**Bureau of Project Delivery
Bridge Design and Technology Division**

<p>BRADD No. 040 November 17, 2014</p>	<p>Integral Abutment: Incorrect Prestress I-Beam Stirrup Detailing</p>
---	---

**Integral Abutment: Incorrect Prestress I-Beam
Stirrup Detailing**

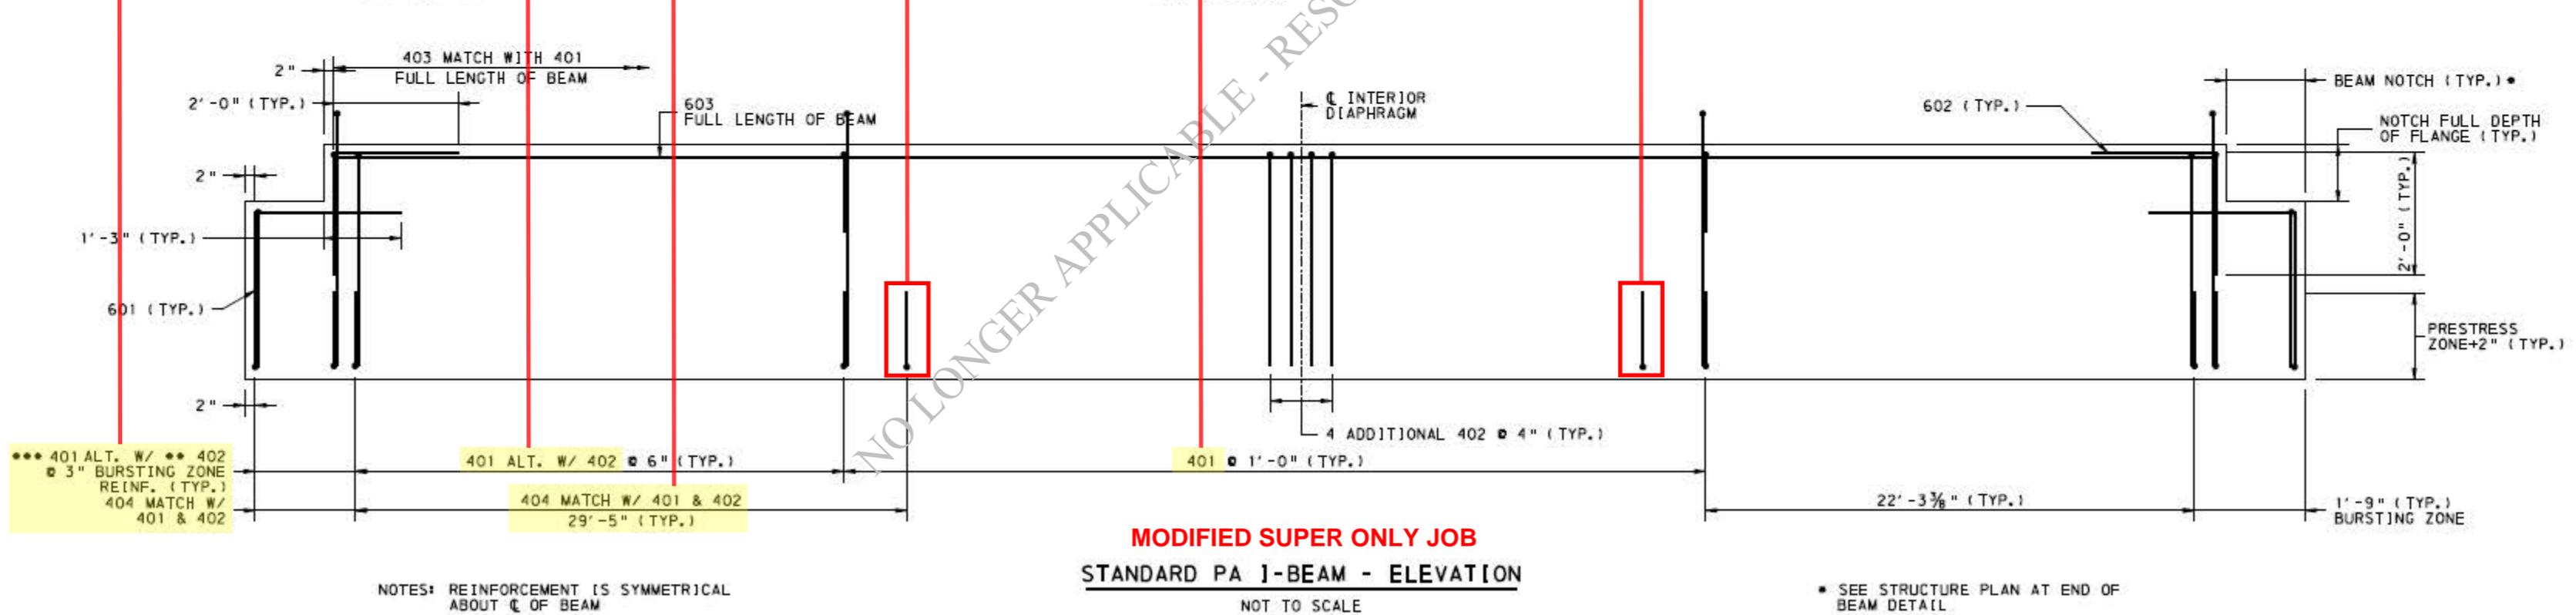
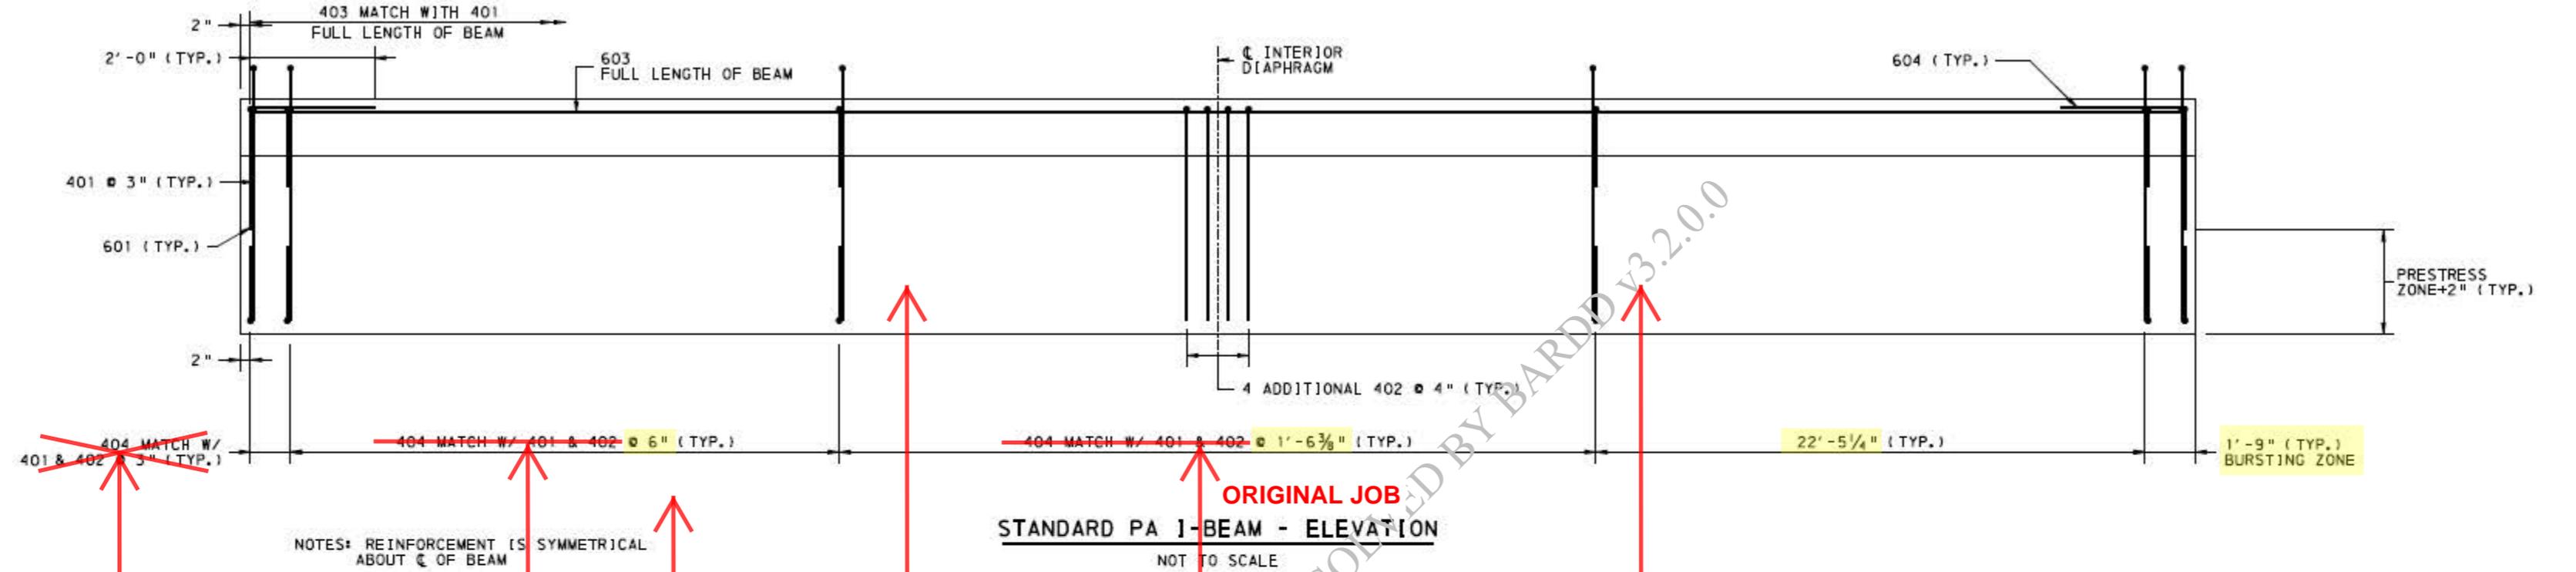
The labeling for the shear stirrup reinforcing is incorrect for Prestress I-Beams without a beam notch in the BRADD BEAM ELEVATION detail. This only occurs for bridges with Integral Abutments.

1. The 404 bars do not end at 1/3 span length.
2. The 401 and 402 bars are called out incorrectly.

A correct BEAM ELEVATION detail for a prestressed beam without a beam notch may be constructed by generating in BRADD a detail of a similar beam elevation *with* a beam notch and then manually copying the relevant stirrup detail information from the similar beam elevation detail with the beam notch to the beam elevation detail of the beam without the beam notch.

4. From the figures below, find the sheet with the beam type of interest (either PA I-Beam, AASHTO I-Beam or PA Bulb-Tee Beam). The top of each sheet shows an example of a BEAM ELEVATION detail containing the incorrect stirrup information (labeled ORIGINAL JOB). The bottom of each sheet shows an example of a BEAM ELEVATION detail created from the same job but with Superstructure Only option (labeled MODIFIED SUPER ONLY JOB). In each figure, items crossed out with red lines are incorrect. Items highlighted in yellow are correct.

5. Copy or replace the items indicated in the attached example that matches the type of I-beam of interest.

ORIGINAL JOB
STANDARD AASHTO TYPE I-BEAM - ELEVATION
 NOT TO SCALE

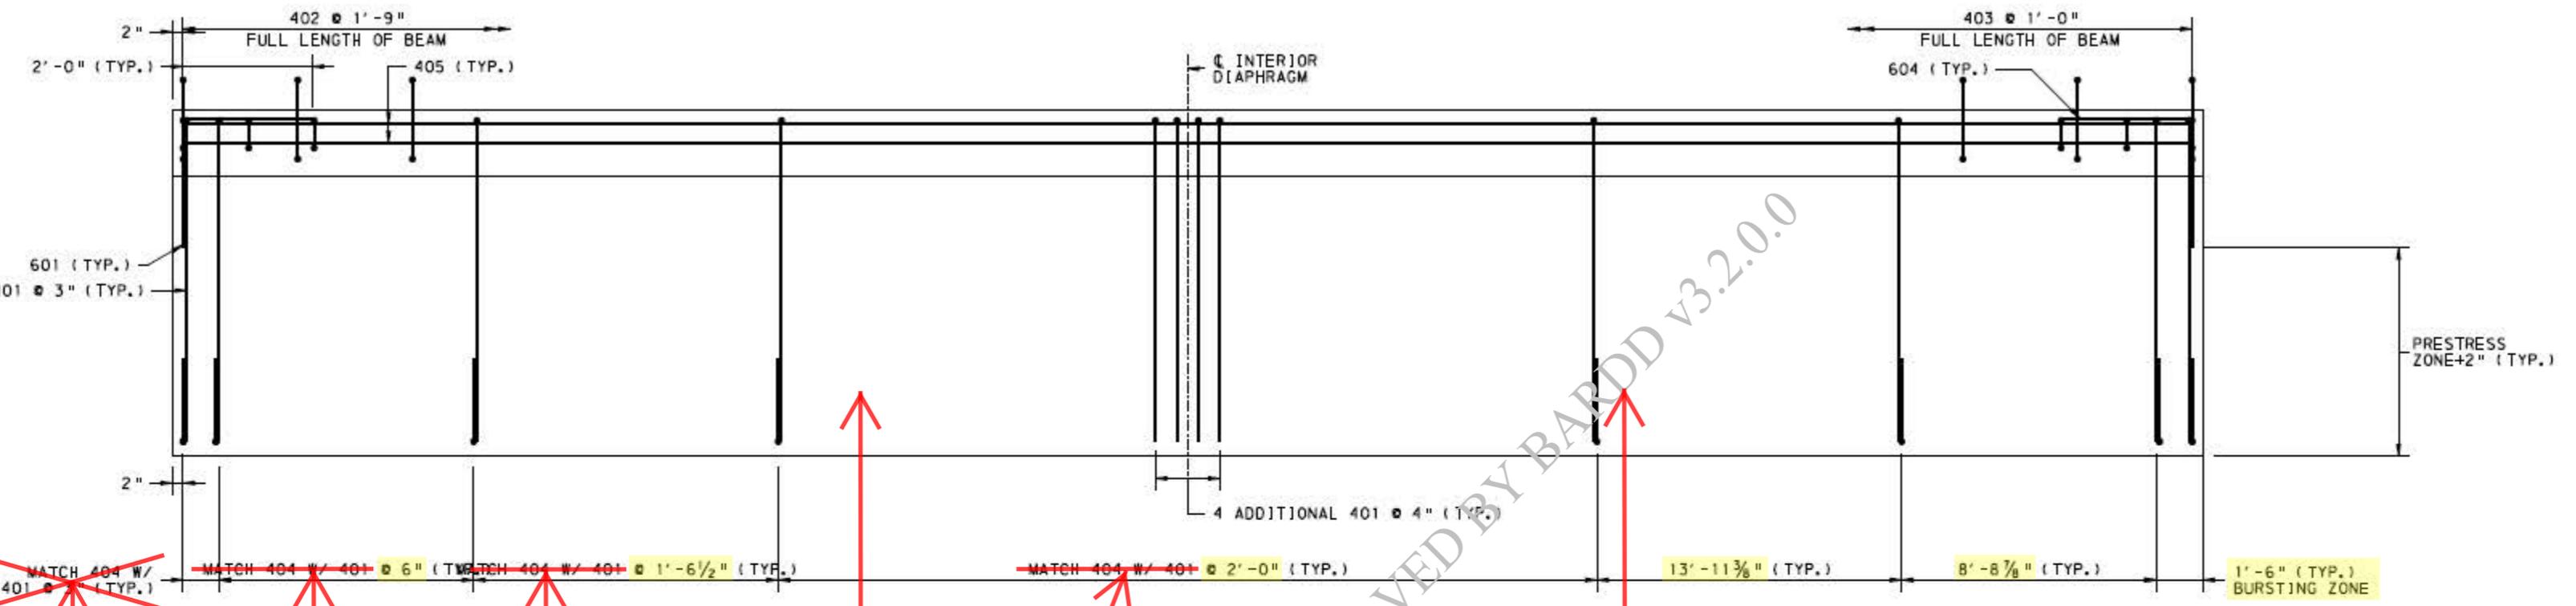
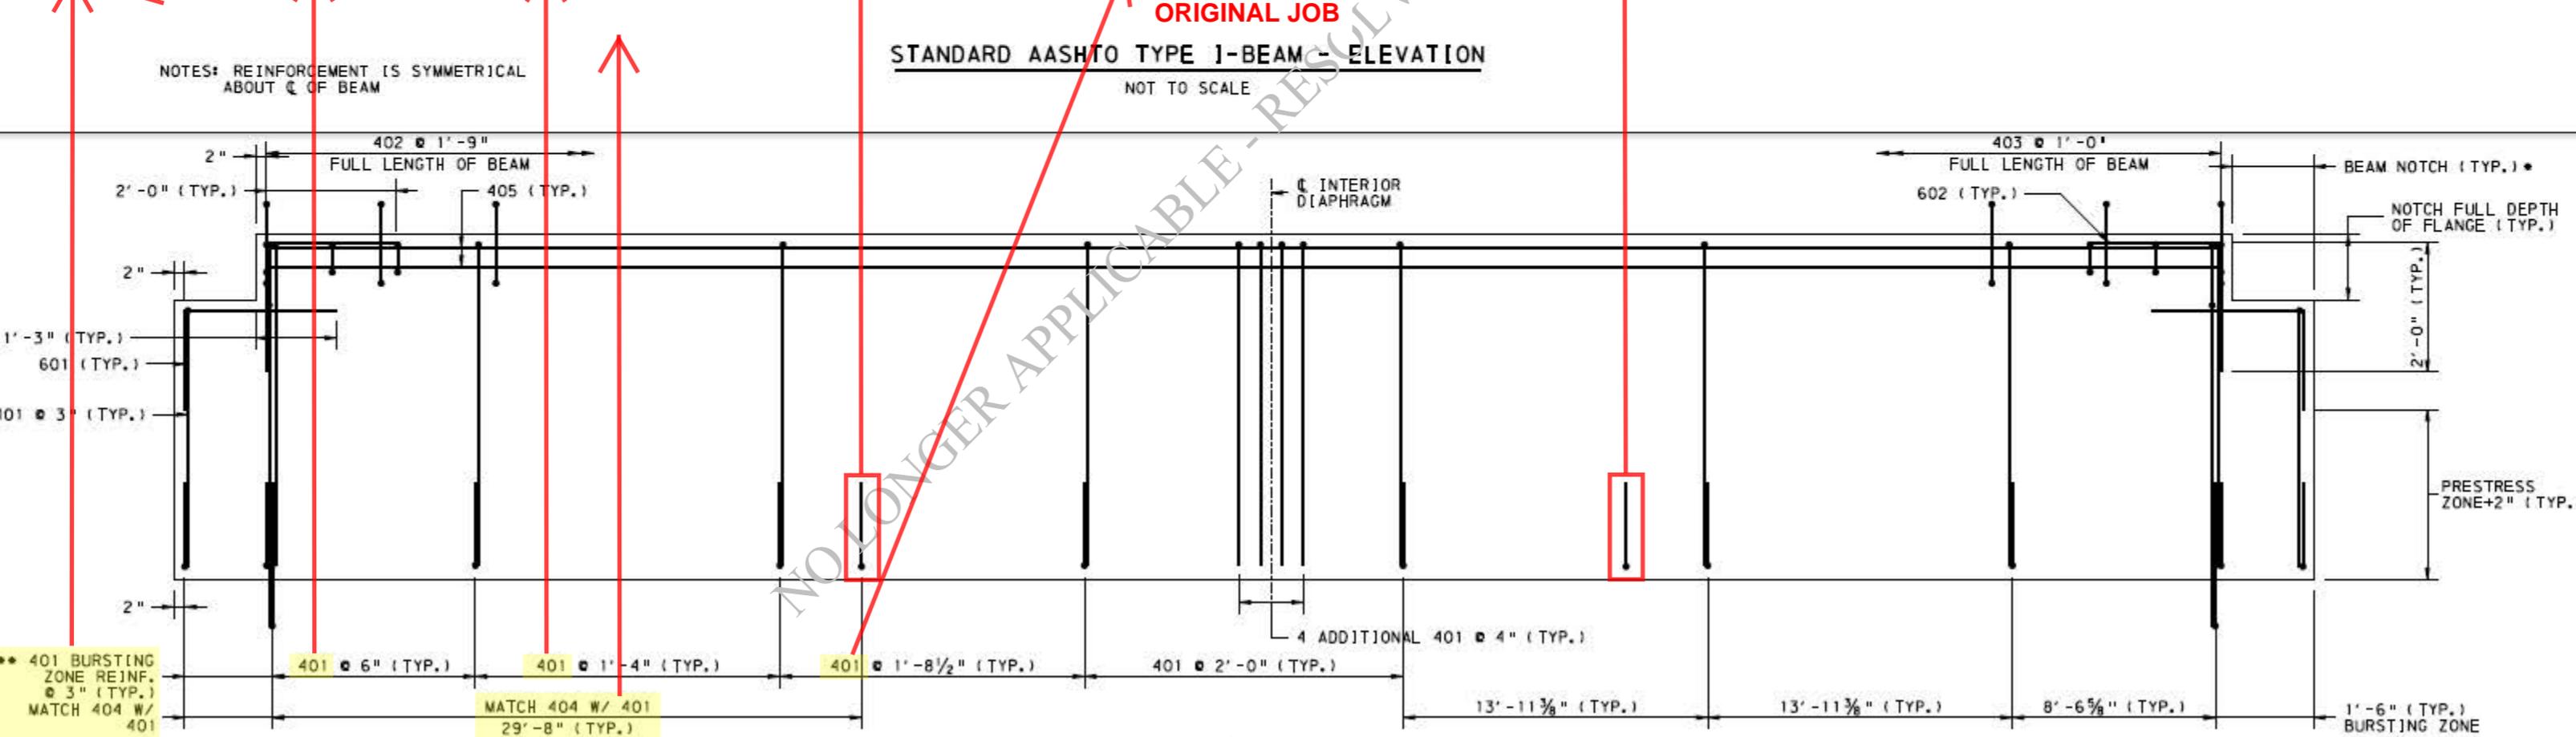
** 401 BURSTING ZONE REINF. @ 3" (TYP.) MATCH 404 W/ 401

MODIFIED SUPER ONLY JOB
STANDARD AASHTO TYPE I-BEAM - ELEVATION
 NOT TO SCALE
